January 14, 2014

SUBJECT: STORM WATER MANAGEMENT POND ISSUE NEAR HIGHLAND PLANT
SMITH RANCH URANIUM *IN SITU RECOVERY* FACILITY, LICENSE
SUA-1548, POWER RESOURCES, INC., CONVERSE COUNTY, WYOMING

Figure 1 – Location of Ponds

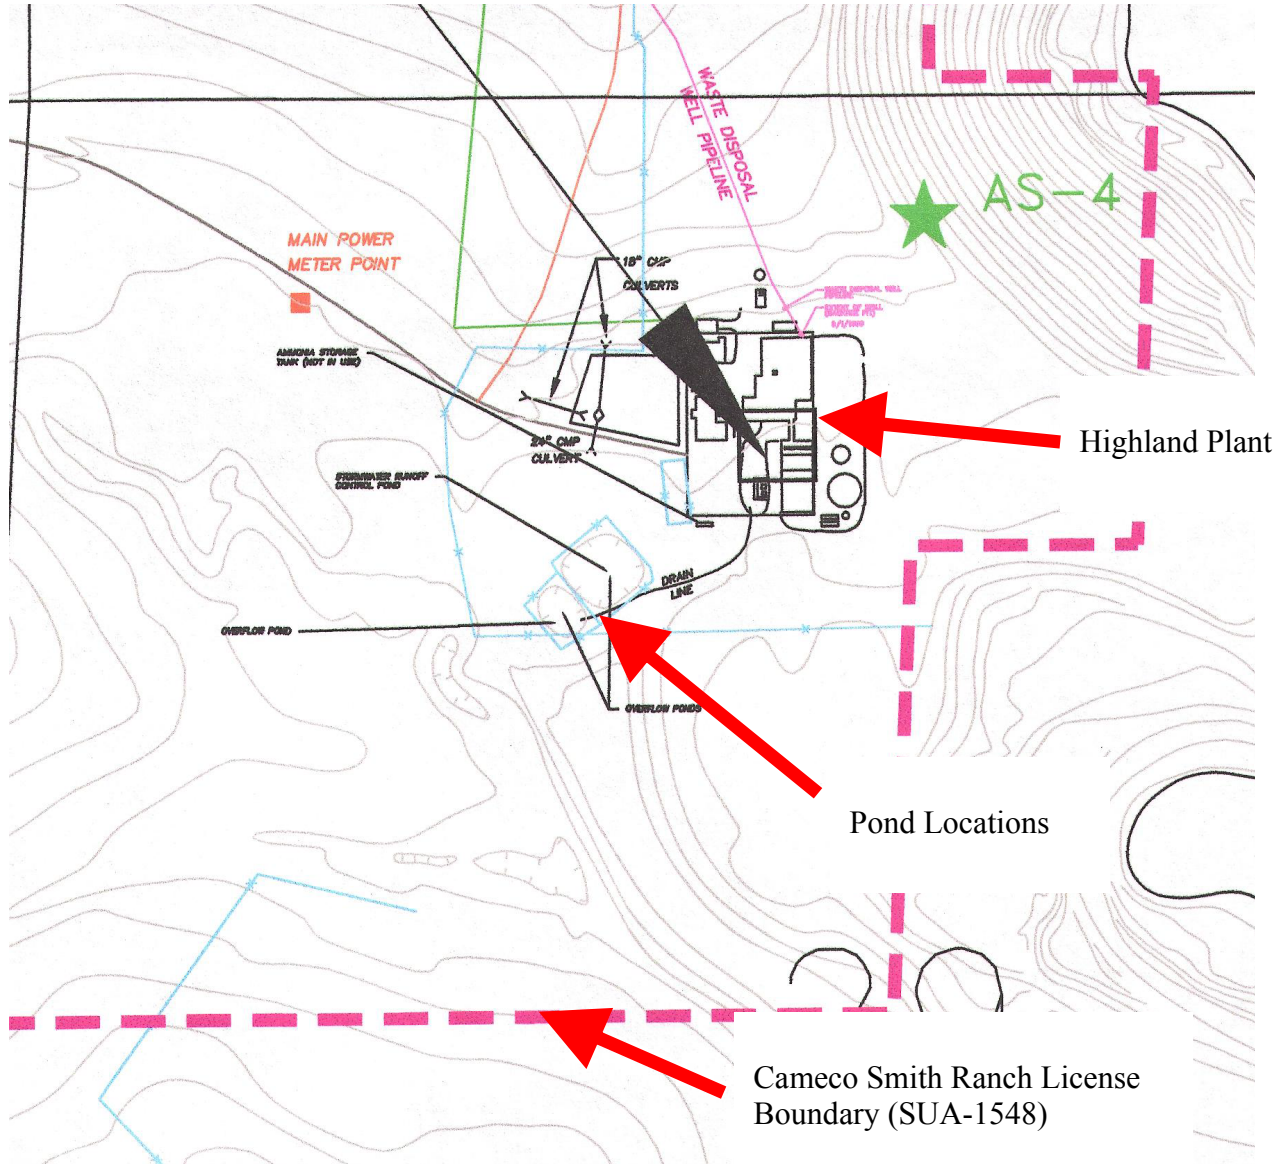
On September 24, 2013, an NRC inspector visited two ponds located near the Highland CPF. The location of the Highland CPF and the ponds are shown on Figure 1. The inspector toured and surveyed the two ponds and found the radiation levels of one pond to be 80 microRoentgens per hour ($\mu\text{R/hr}$) at the edge of the pond liner. The background in that area was found to be approximately 15 $\mu\text{R/hr}$. This reading indicates radioactive contamination is present within the pond. The outside edge of the second pond area had no discernible radiation above background. The ponds are located within a fenced area with a locked gate. The inspector also observed a pump house that appears to contain equipment necessary to move liquid to the ponds. The ponds do not appear to be in use currently as uranium in-situ recovery (ISR) operations at the Highland CPF remain on standby. It is not clear if the ponds are necessary to support future ISR operations at the Highland CPF.

As the ponds are located within the current boundary for materials license SUA-1548, the staff asks that Cameco:

- 1) Determine whether the ponds and associated infrastructure (e.g., pump house and piping) are currently being used.
- 2) Determine whether or not the ponds and associated infrastructure are necessary to support future ISR operations at the Highland CPF.
- 3) If the answers to the first two questions are no, Cameco should commit to decommission and reclaim the ponds in a timely manner as required by 10 CFR 40.42.
- 4) If the answer to either of the first two questions is yes, Cameco should identify what, if any actions, are required to continue use of the ponds.
